Newmar Corporation Warranty Department

Technical Service Bulletin

| Date Issued | Model Year(s) Affected | | Model(s) Affected | | TSB # |
|---|--|---|--|--|-------|
| 12/29/2010 | 2002 - 2010 | | | | 379 |

SAFETY RECALL NOTICE

How to identify recalled plug-in remote control receivers:

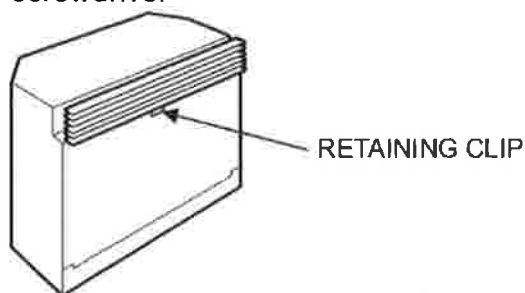
This style of recalled plug-in receivers have Model Numbers 47-1001 and 47-1010-R or DOC ID # 255K656-61-8367R

This style of recalled plug-in receiver has Model Number APT-1315

Dimplex North America will send you a new plug-in remote control kit, Model No. 47-1010-R* (note the asterisk *), at no charge for each kit listed on the form. On the new version, the name “Dimplex” appears on the front of the receiver in red.
